REQUEST TO AMEND THE ORDER OF CONDITIONS

Residential Redevelopment 27 Cross Street Newton, Massachusetts

Re: Request to Amend the Order of Conditions
27 Cross Street
Newton, MA, 02465
MassDEP File #239-0939

Date of this memo: JUNE 15, 2023

- Sheet 2 of 5

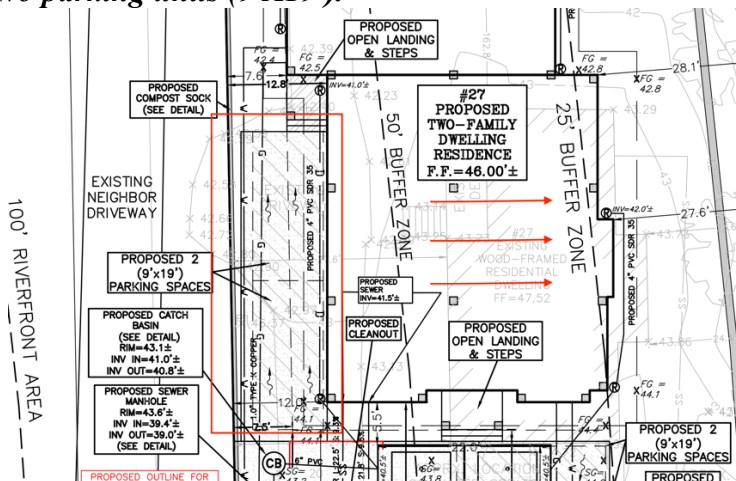
- **Response to City Request:** The city has requested that two additional parking units needs to be added, to achieve this the following modifications have been made.

The front unit has been moved to the right, freeing up a 12 foot wide space, which will accommodate two parking units (9'X19').

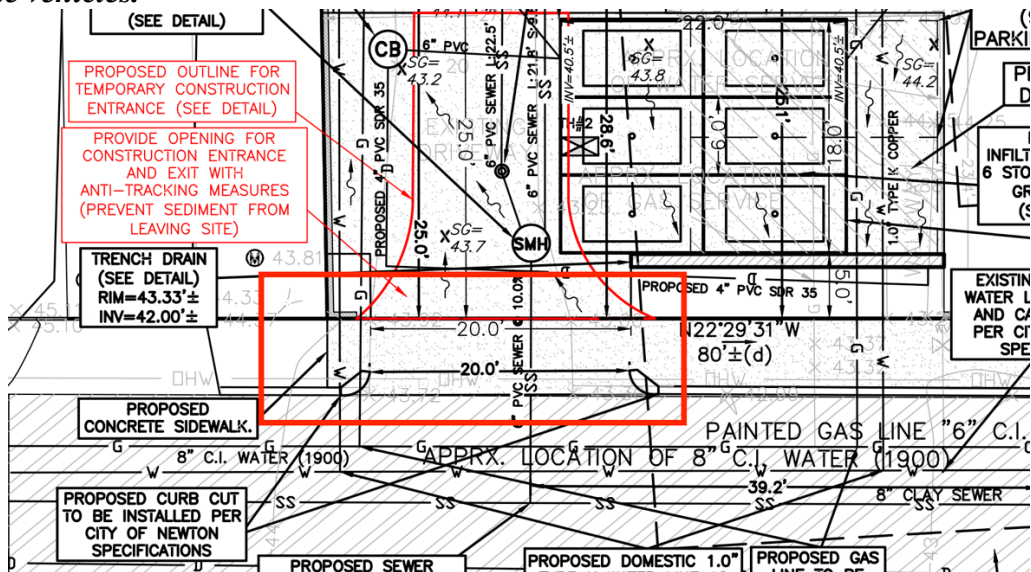
The entrance to the driveway has been modified, in order to ensure the maneuverability of the vehicles.

- **Turn Analysis**

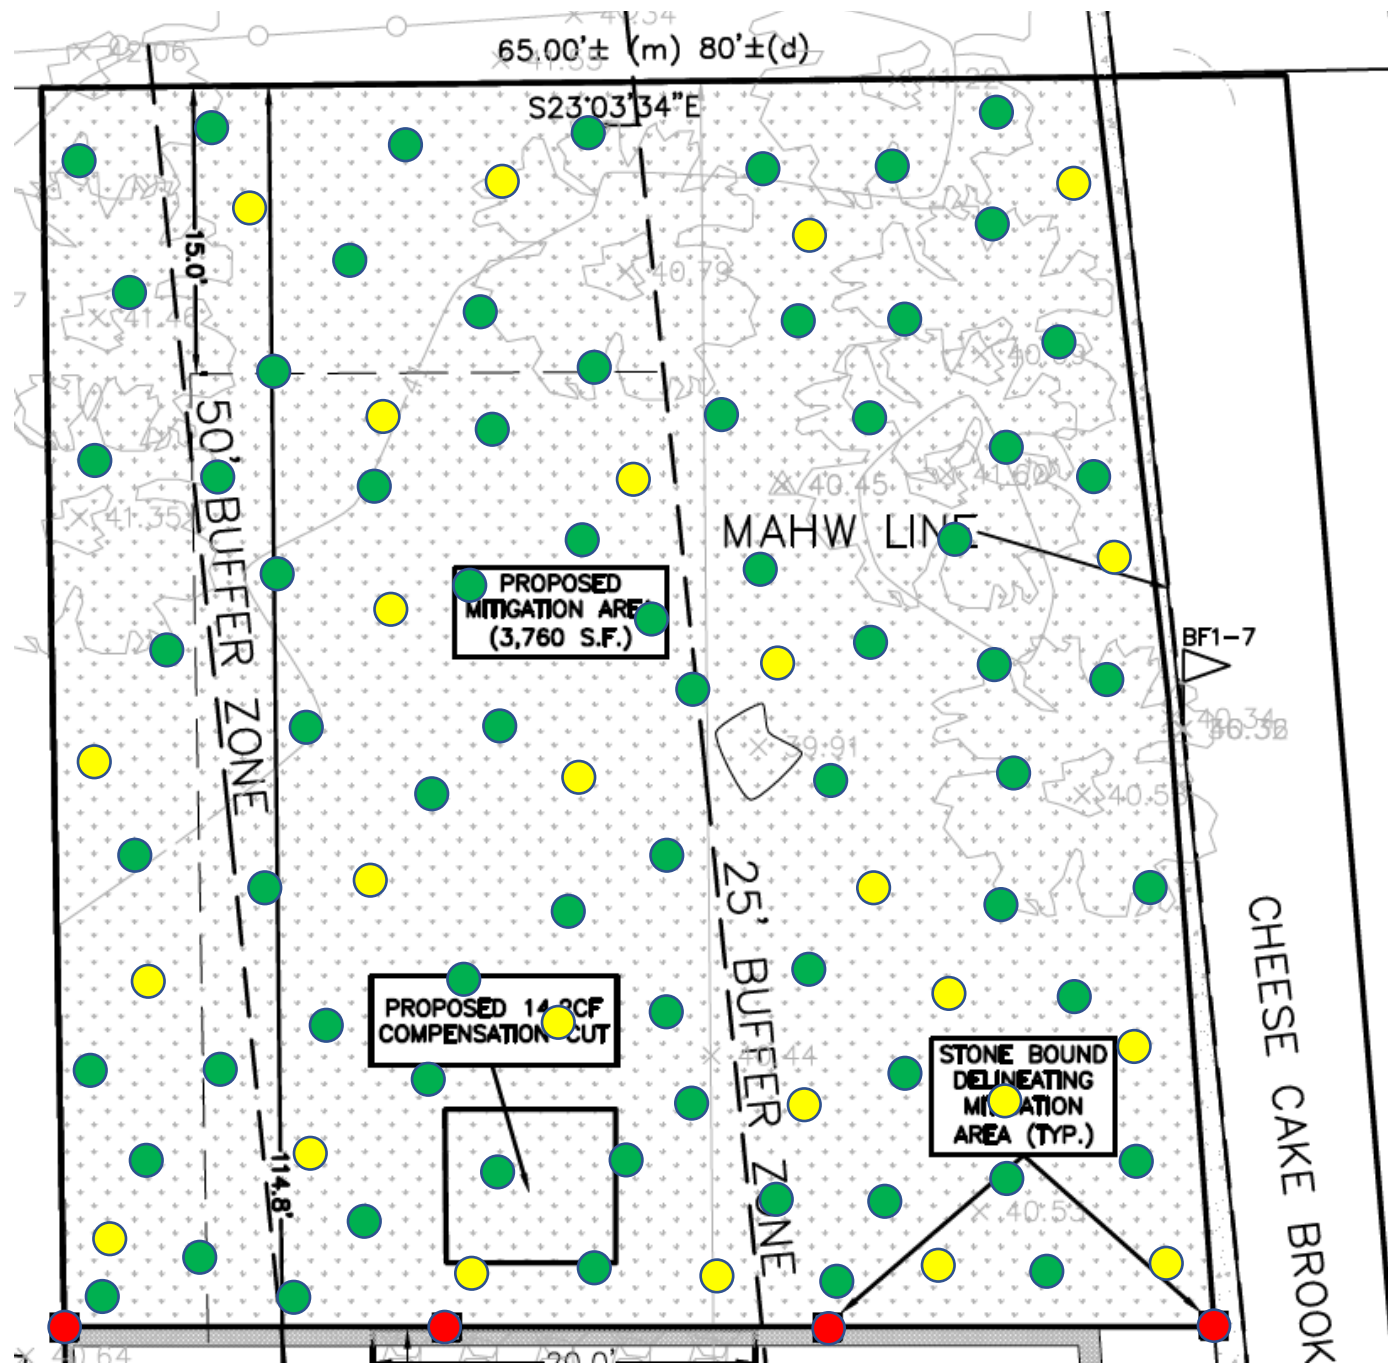
Additionally, a turn analysis has been carried out, where it is verified that the parking spaces are fully functional.
